Joseph M. Farley Nuclear Plant - Unit 2  
Response to Request for Additional Information  
Regarding Fall 2002 Steam Generator Inspection

Response to Request for Additional Information  
Regarding FNP 2R15 Steam Generator Inspection

Tubesheet Map (Hotleg Side) for Westinghouse Model 54F Steam Generators  
as used at Farley Nuclear Plant

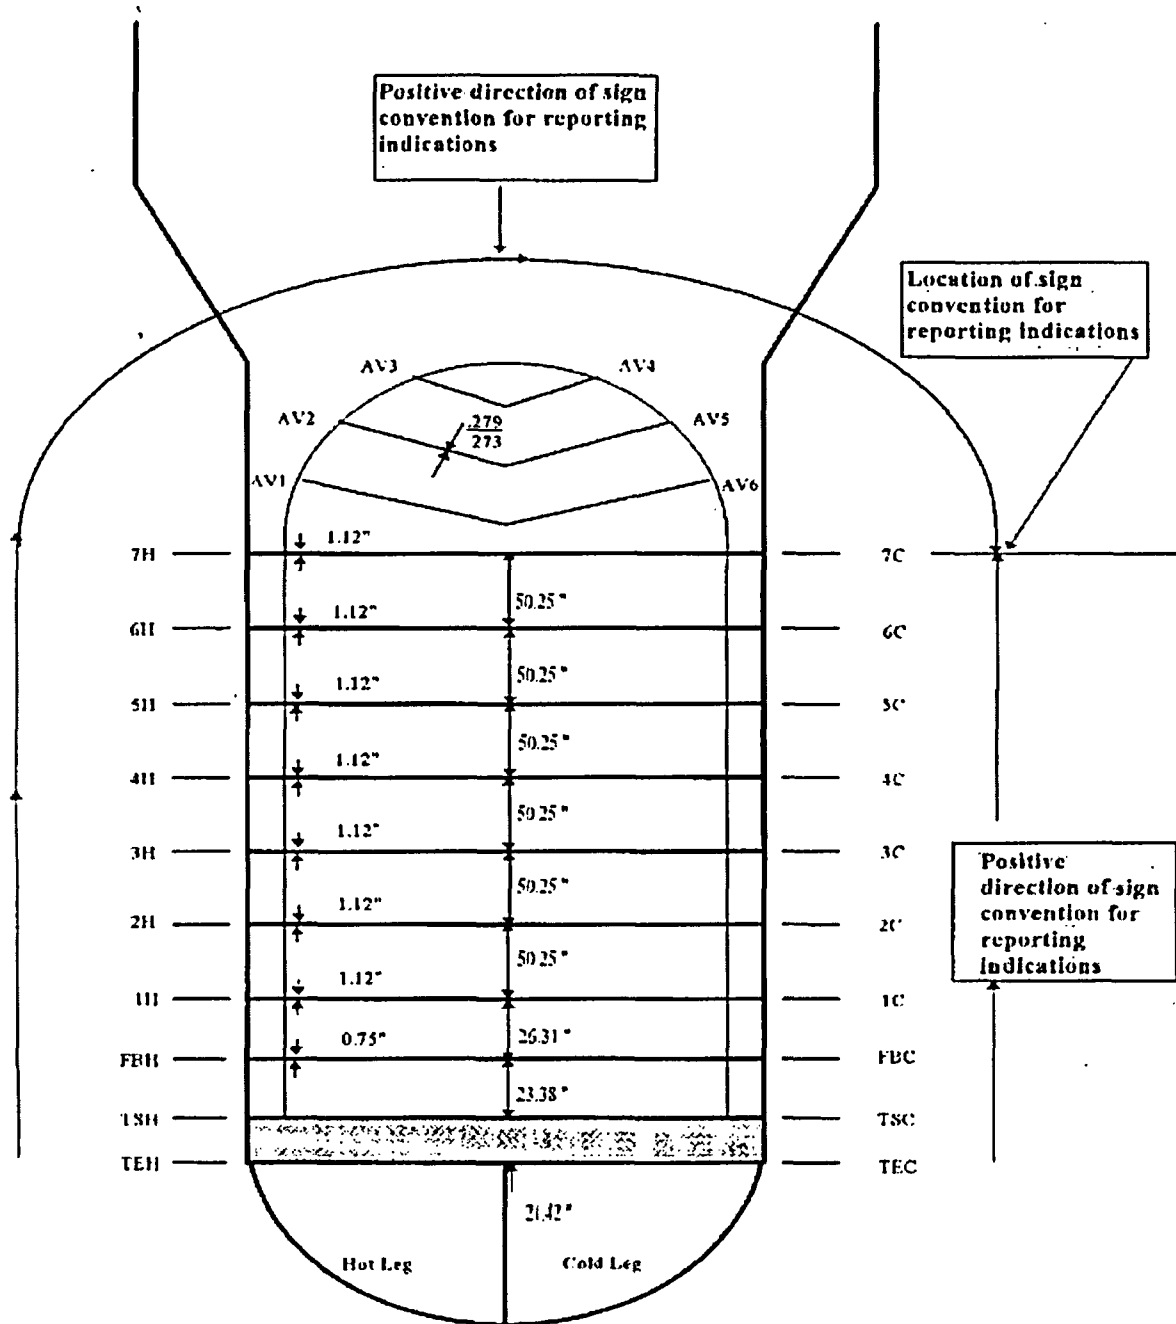
**General information concerning the design of your replacement steam generators was provided in previous submittals. In order for the staff to better understand the design of your replacement steam generators, please provide the following information: tube manufacturer, tube support thickness, tube pitch and pattern, number of tubes plugged (if any) in each steam generator prior to installation, tubesheet thickness, tubesheet map, and a sketch of the steam generator depicting your tube support plate naming convention. In addition, please clarify what rows of tubes have a centerline radius less than 12-inches (i.e., what rows of tubes had the U-bends stress relieved).**

Tube Pitch and Pattern: 1.225", Square Pitch
